Technical Briefing Note

Our Reference: 24675.115526

RFI Response – Gunyah Park Dairy

YURUNGA GUNYAH PARK - DA RESPONSE

VEHICLE ENTRY AND MANOEUVRING PLAN

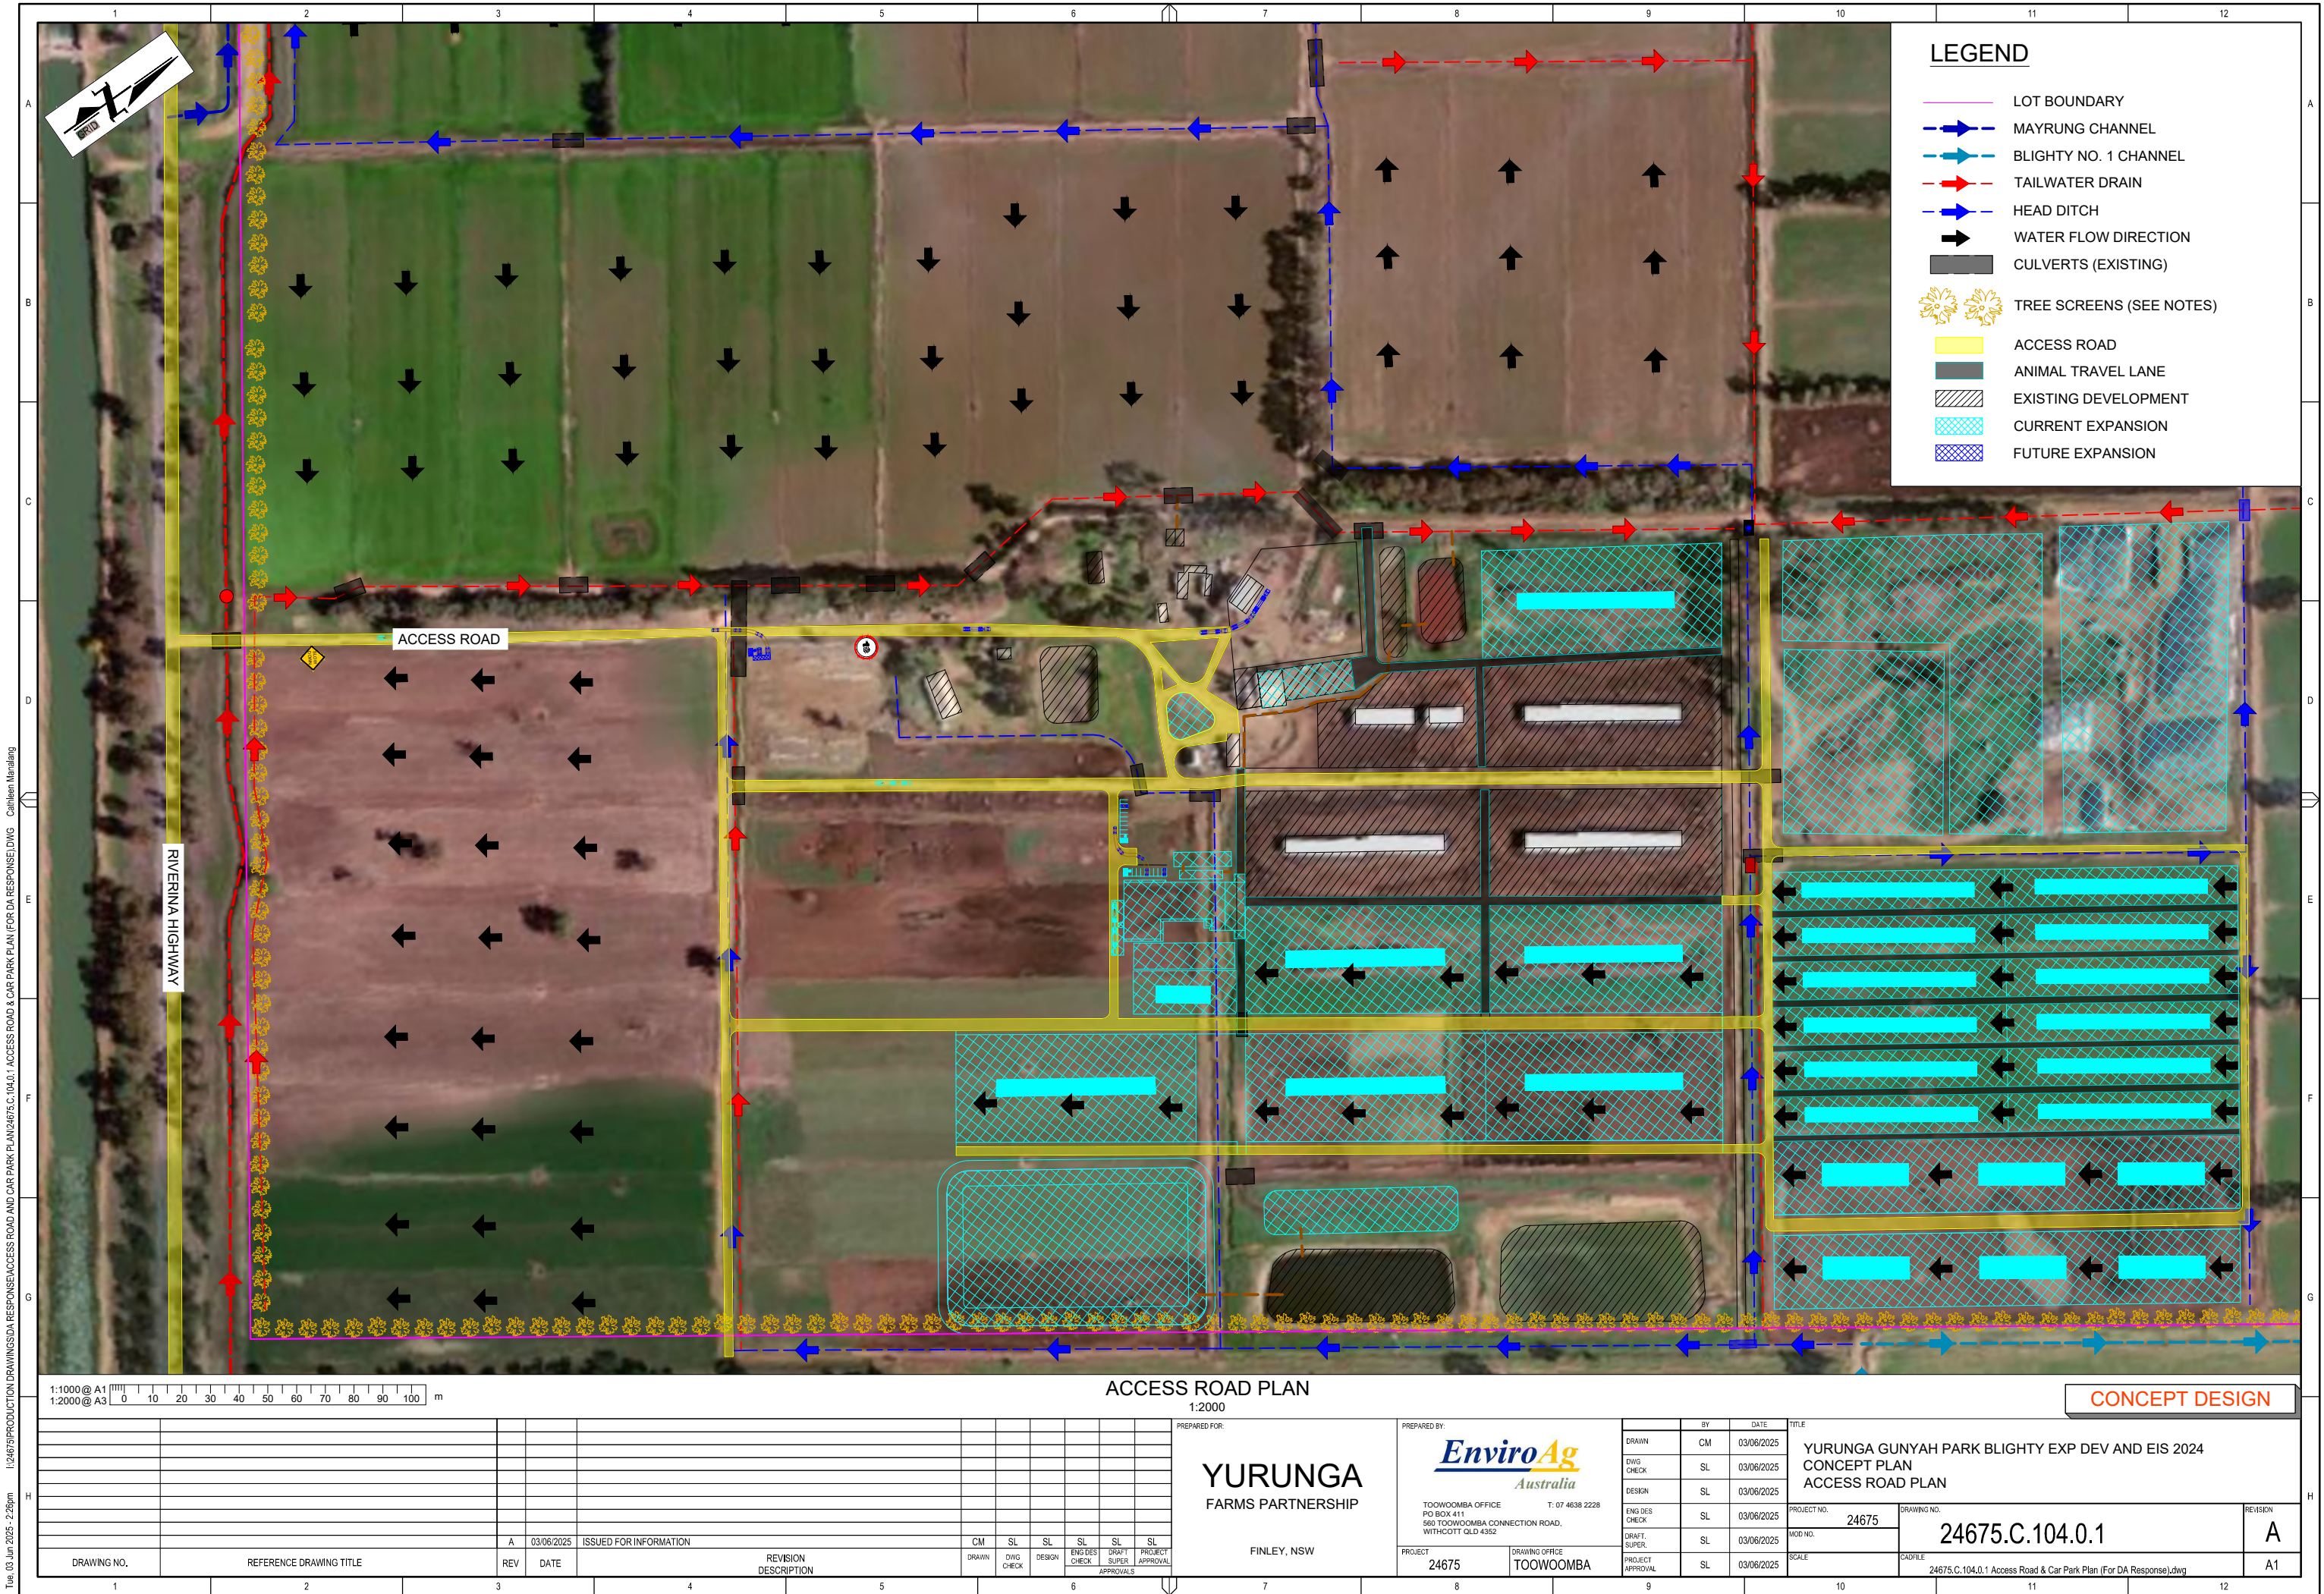
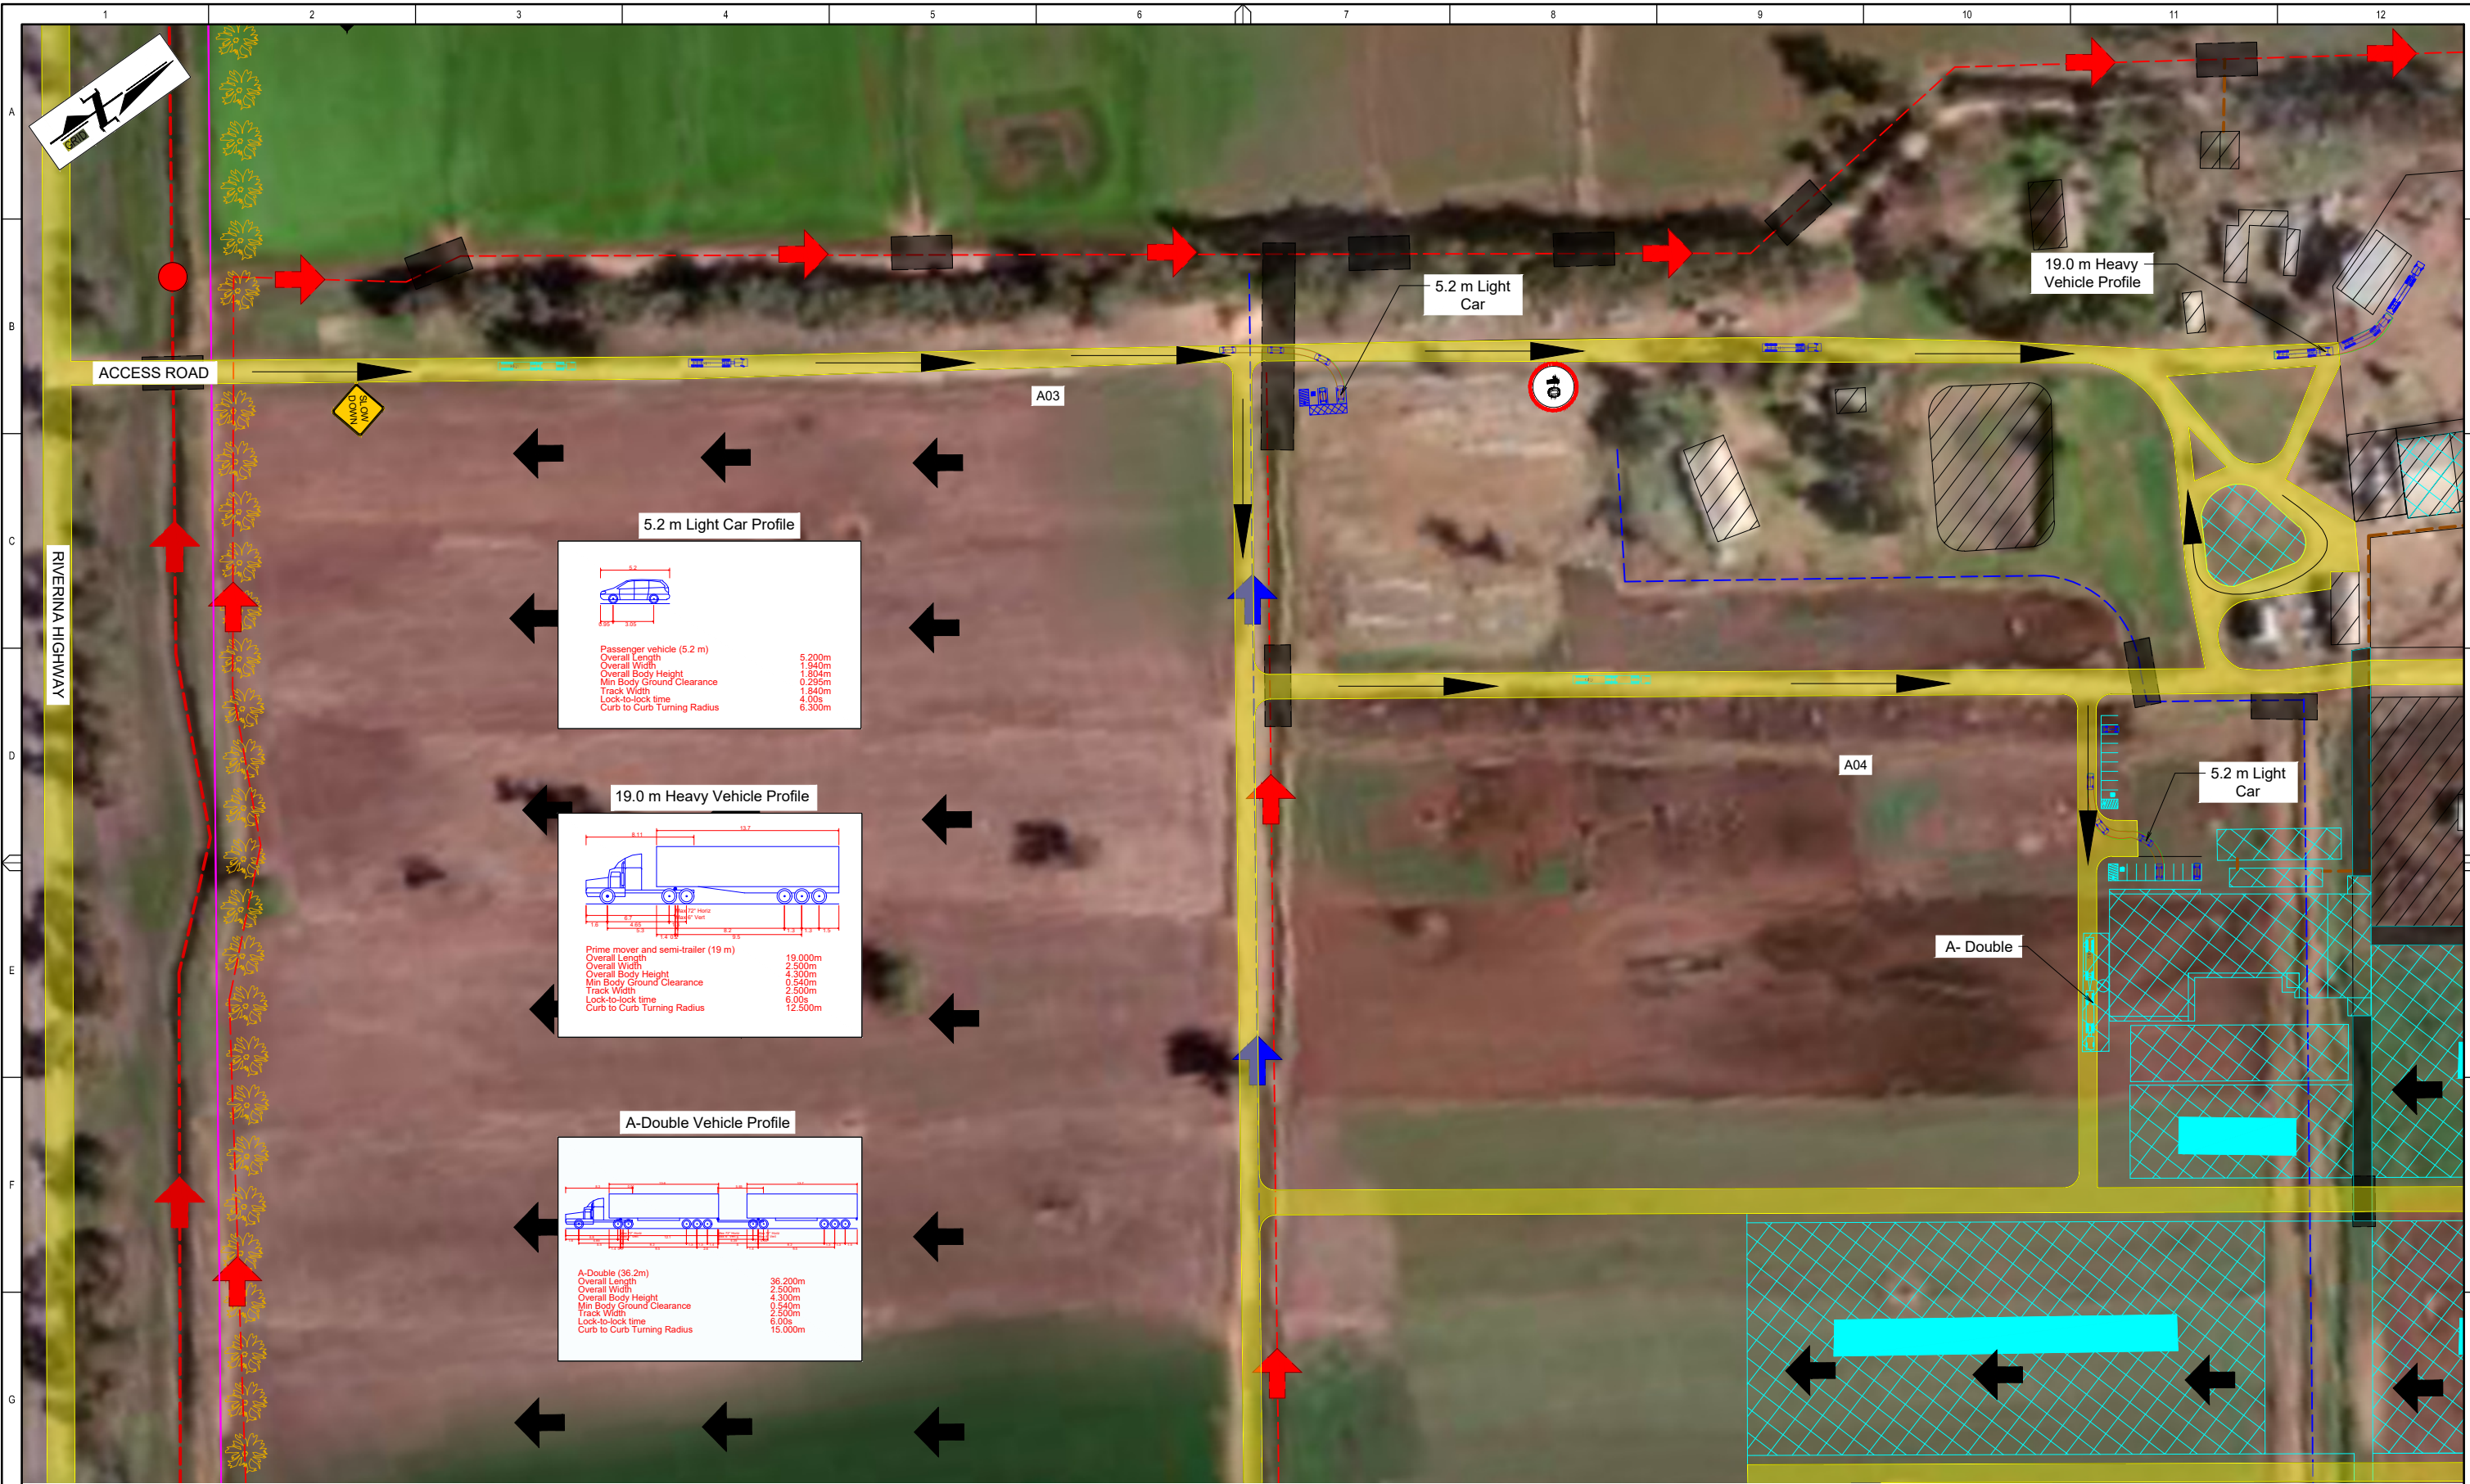
runoff CDA management), car parking plan and internal manoeuvrability/ internal access plan, and any other new infrastructure not listed

Washdown Facility	Detailed floorplans and elevations are now included for the washdown facility. These also include design elements for runoff management and Controlled Drainage Area (CDA) control.	<p>Appendix B drawing pack:</p> <ul style="list-style-type: none"> • Sheet 002: 24675.C.001.0.1 Overall Site Plan • Sheet 008: 24675.C.360.1.1 Washdown Facility Plan
Car Parking and Internal Access	<p>Plans now include layouts for car parking areas and internal manoeuvrability, demonstrating how vehicles will access, circulate, and exit the site safely and efficiently.</p> <p>A Traffic Management Plan is also provided for internal traffic management.</p>	<p>Appendix B drawing pack:</p> <ul style="list-style-type: none"> • Sheet 009: 24675.C.104.0.1 Access Plan • Sheet 010: 24675.C.104.1.1 Car Park Plan • Sheet 011: 24675.C.104.2.1 Vehicle Entry and Manoeuvring Plan • Sheet 012: 24675.C.104.3.1 Vehicle Departure and Manoeuvring Plan <p>Appendix D <i>Traffic Management Plan</i>.</p>
